March 29, 2022

RE: Design Review Application Project Address: 7950 Bodega Avenue

|    | Prelim Design Review Comments  | Response  |

SHEETNO.: A4.0 (NEW SHEET)

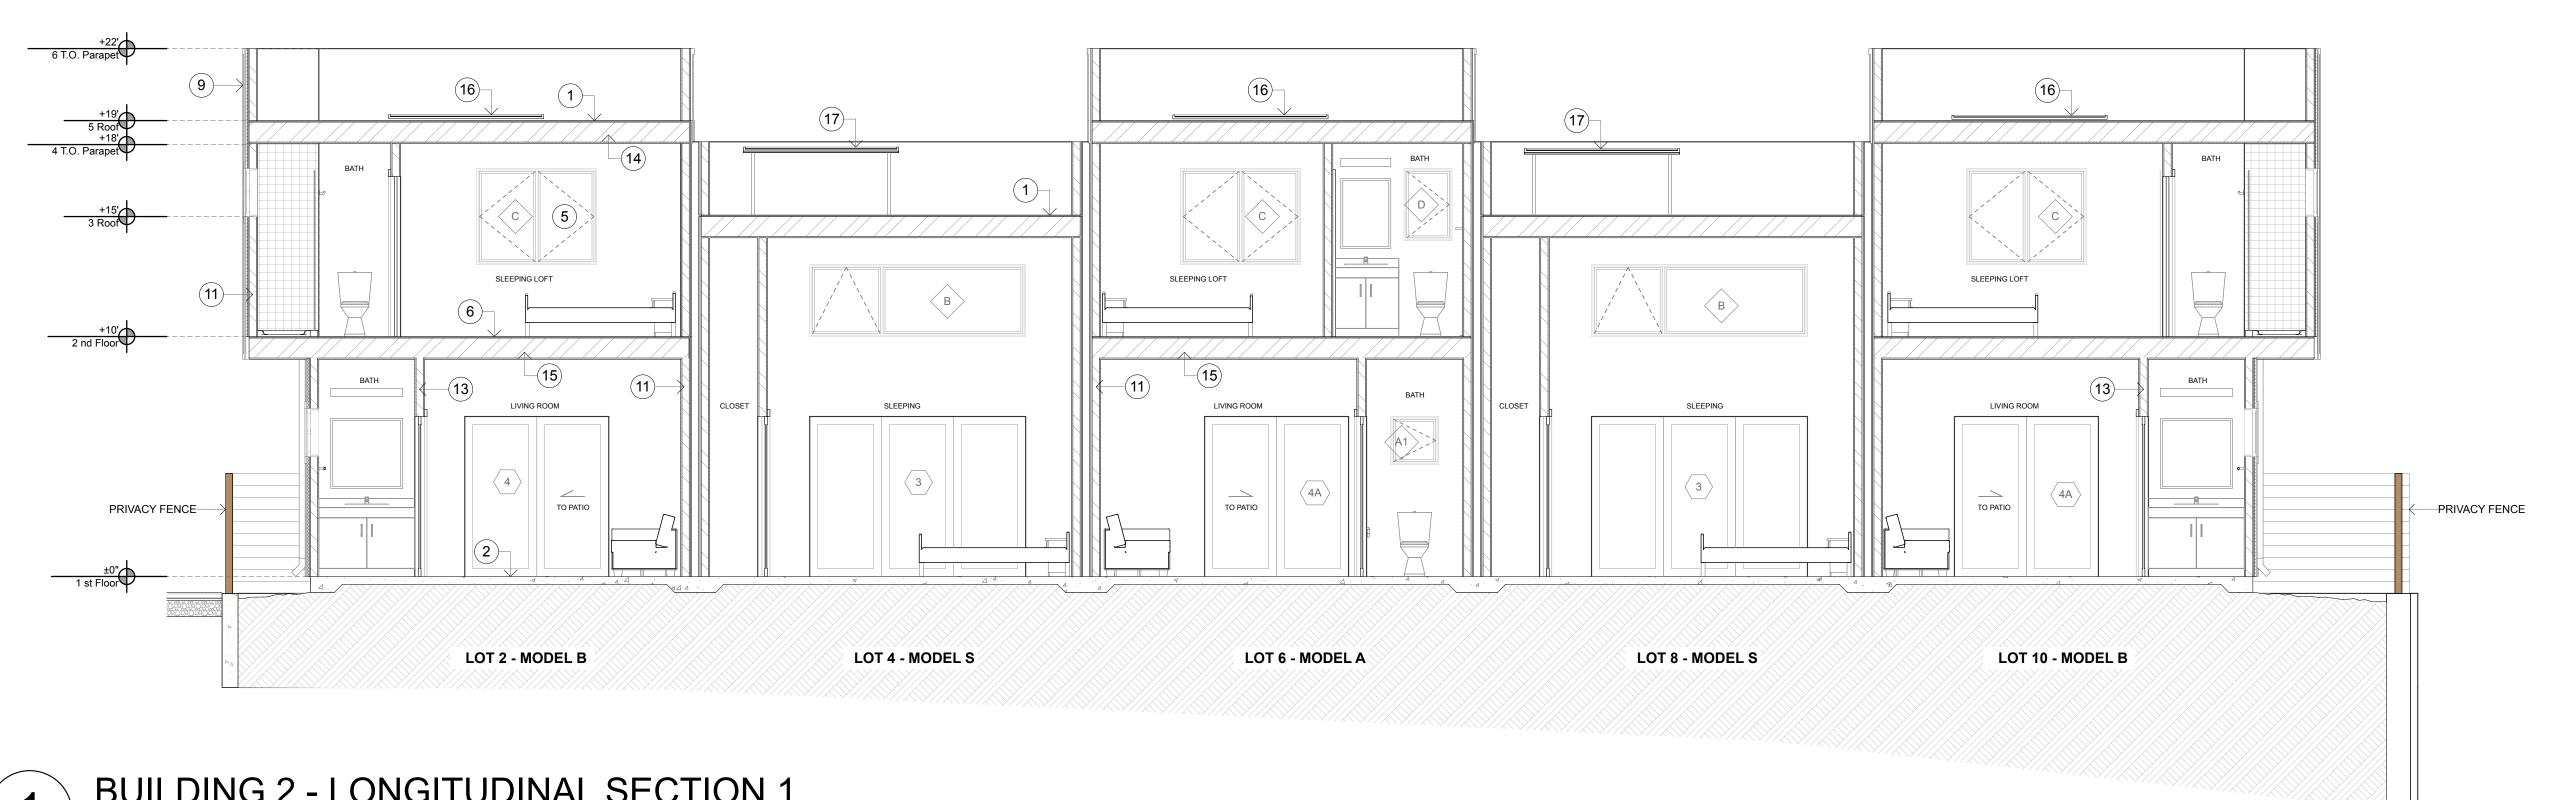
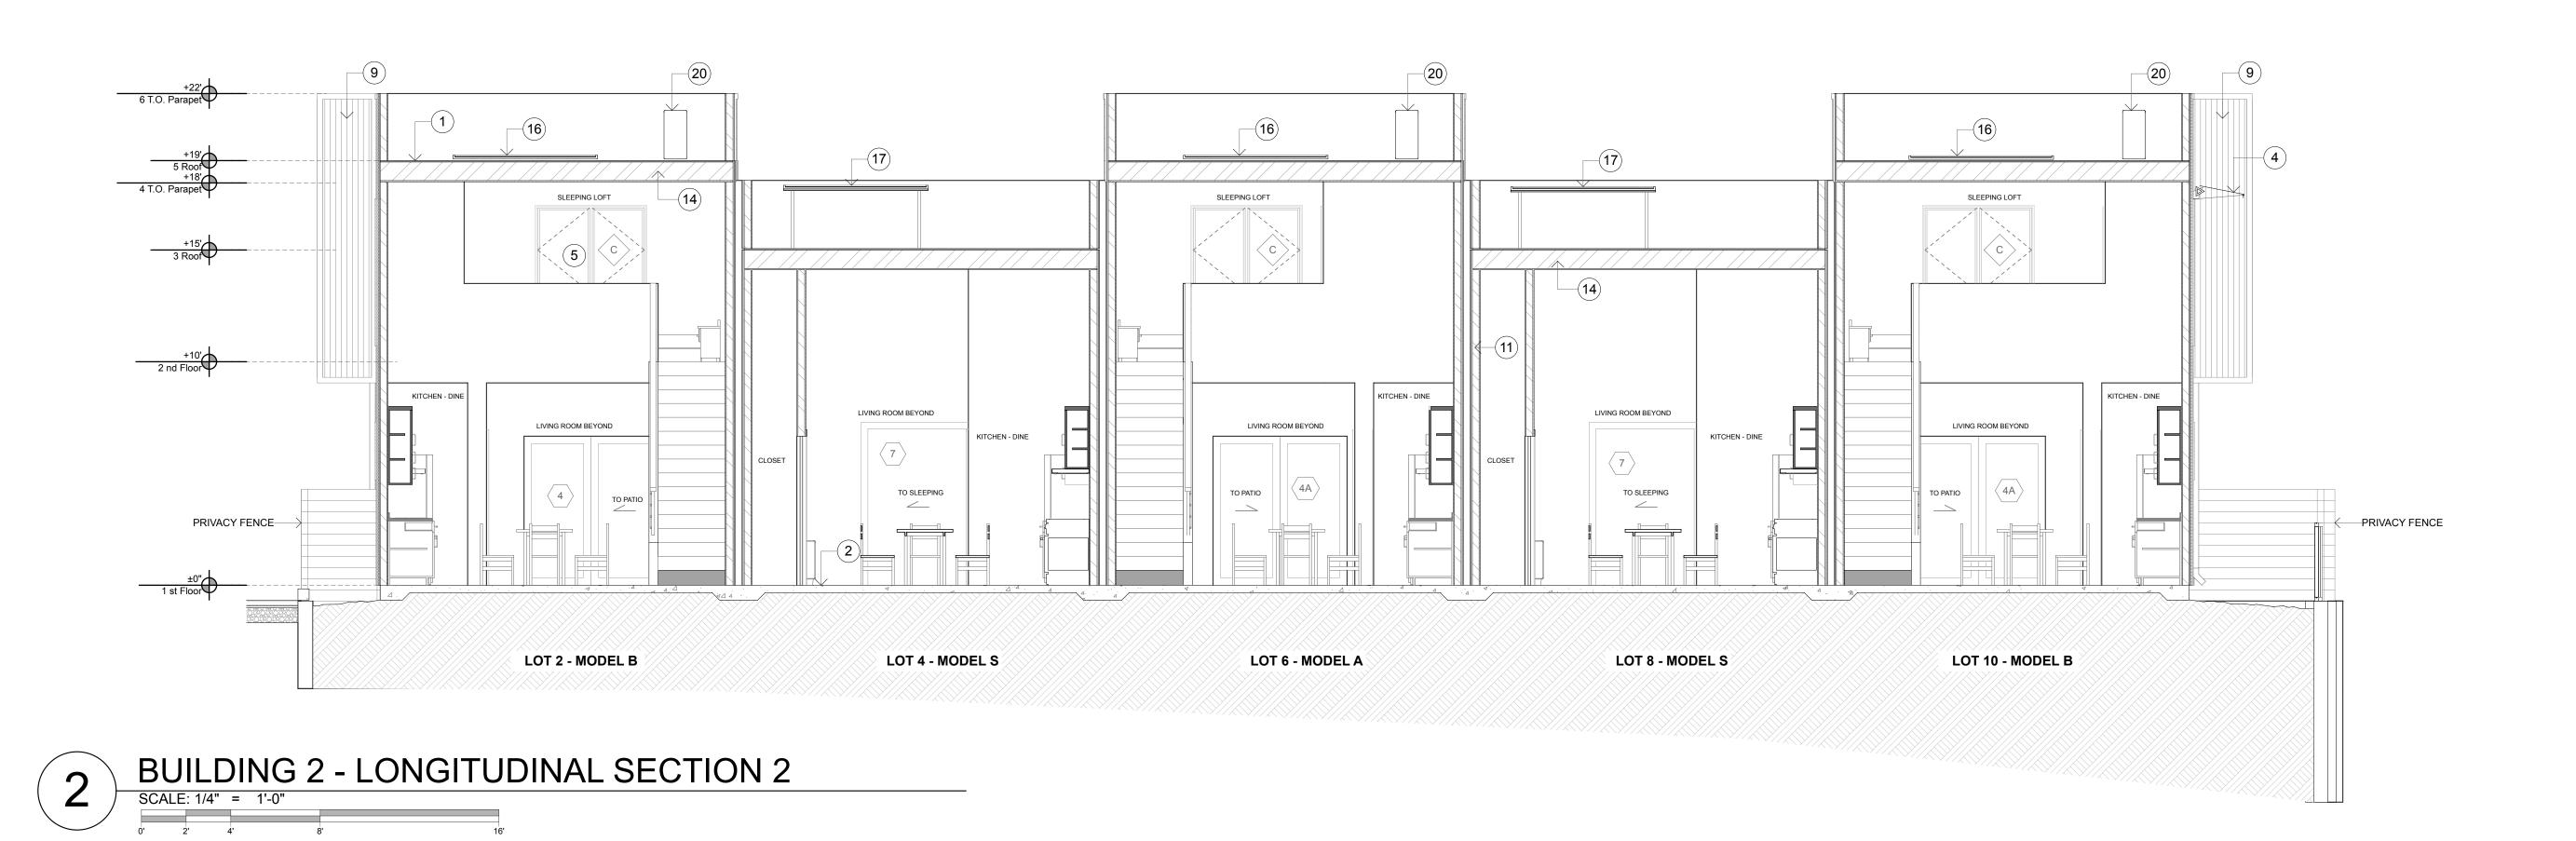
|    | Prelim Design Review Comments  | Response  |
|----|--|---|
| 4  | Need drawing of project showing the neighboring buildings for scale  | New sheets A3.0 and A4.0 both show the relationship to the neighboring buildings  |
| 14 | Curb at back of sidewalk and sloped planting bed up to retaining wall                                      | See sheet A4.0. We have added a 12" curb at the back of the sidewalk on Bodega Avenue and sloped the landscape up the wall to reduce the appearance of the retaining wall height. You can also see this on sheet A3.1.  |
